RE: 6-ZN-2023 and 2-GP-2023
Sundown Commons
6C395 and 95S87

Planning & Development Services has completed review of the above referenced development application. The following comments represent issues or deficiencies identified by the review team and are intended to provide you with guidance for compliance with city codes, policies, and guidelines.

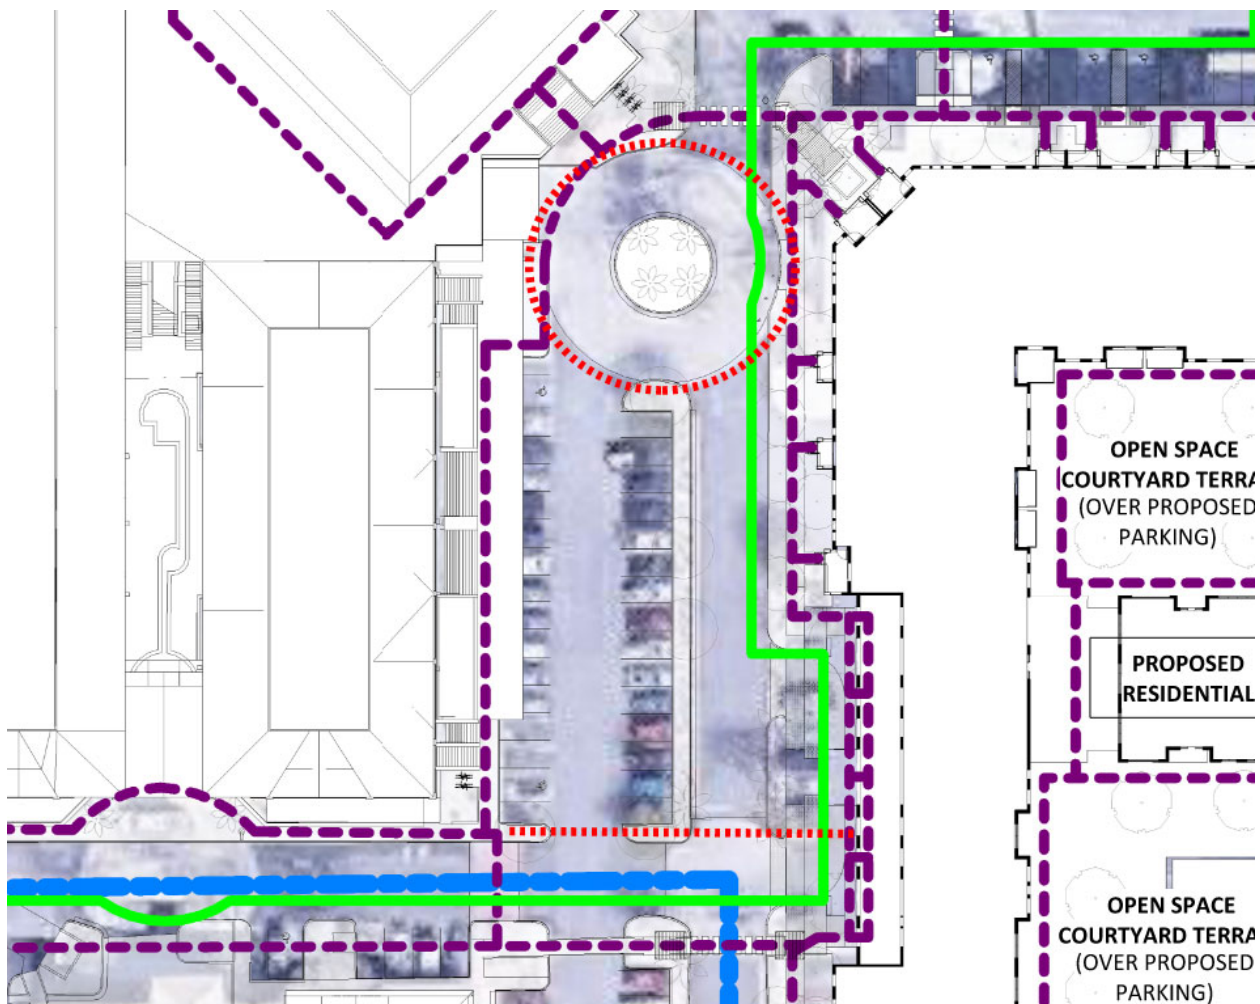
7. Please remove the two southeast parcels from the project scope and improvements as those parcels are owned by the City. The applicant will need to purchase these properties (and include them in the General Plan and Zoning case boundaries) or remove from the scope of the applications.

If the applicant wishes to pursue purchasing the properties, please work with the Real Estate department and update all submittal documents to list the true scope of the cases – boundaries, net lot area, gross lot area, APNs, addresses, vicinity maps, parking, etc.

If the subject parcels are purchased, strongly consider revising the site plan to relocate the pickleball courts to be in a more internal location to the site, as opposed to abutting E. Shea Boulevard, a major arterial street (or swap the pickleball and dog run locations). The pickleball courts are surrounded by hardscape and there may be a more appropriate landscaped setting elsewhere on site.
